CODE CHANGE PROPOSAL FORM

Topic of proposal: Assisted Living unit types

Code or rule section to be changed: IBC 1108.5 – 1108.6.3 with MN 1341 Amendments

Firm/Association affiliation, if any: CCLD Topic of proposal: Toilet Clearance depth & Compartment Size

**FIGURE 604.3
SIZE OF CLEARANCE FOR WATER CLOSET**

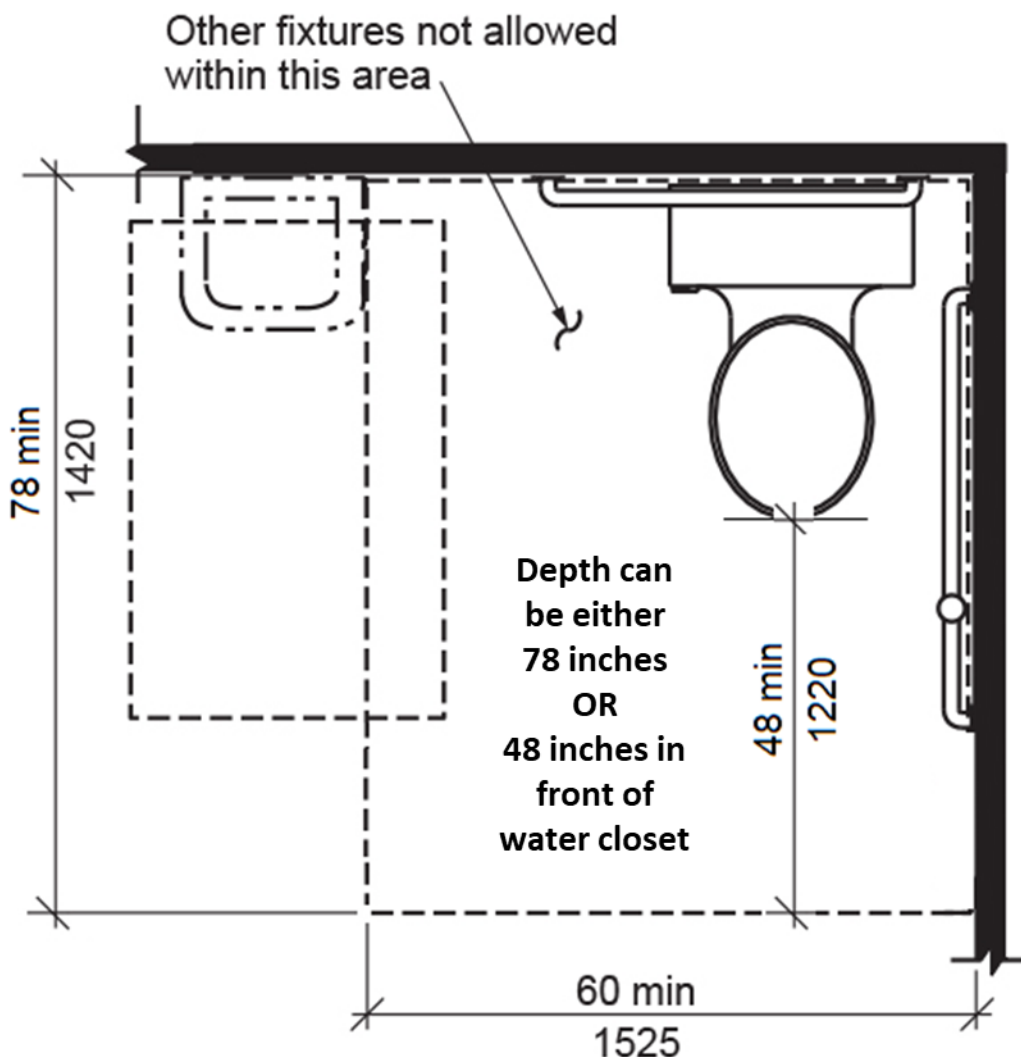
Replace the MN Figure 604.3 with the modification shown below which used improved A117.1 figure, but with MN rule dimensions.

604.3 Clearance. (Carry forward MN 1341 language for 604.3.2 – 604.3.3)

FIGURE 604.9.2(A)

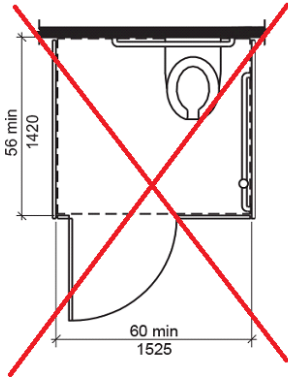
~~WHEELCHAIR TOILET COMPARTMENTS WALL HUNG CLOSET, ADULT~~

FIGURE 604.9.2(B)

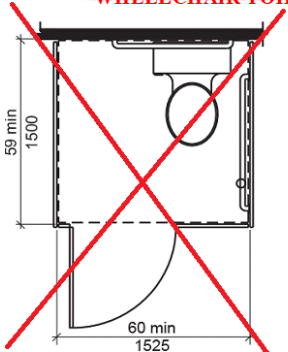
~~WHEELCHAIR TOILET COMPARTMENTS FLOOR MOUNTED WATER CLOSET, ADULT—WALL HUNG AND FLOOR MOUNTED WATER CLOSET, CHILDREN~~

FIGURE 604.9.2.3
WHEELCHAIR TOILET COMPARTMENTS ALTERNATE WHEELCHAIR TOILET
COMPARTMENT

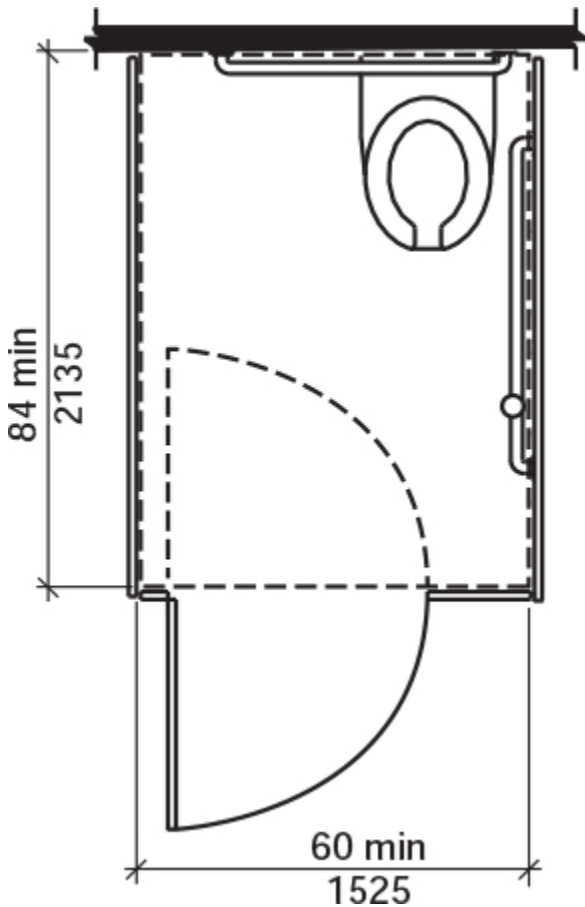
Where an alternate wheelchair accessible toilet compartment is provided the minimum area of the compartment shall be 60 inches (1525 mm) minimum in width, measured perpendicular to the side wall, and 84 inches (2135 mm) minimum in depth, measured perpendicular to the rear wall.
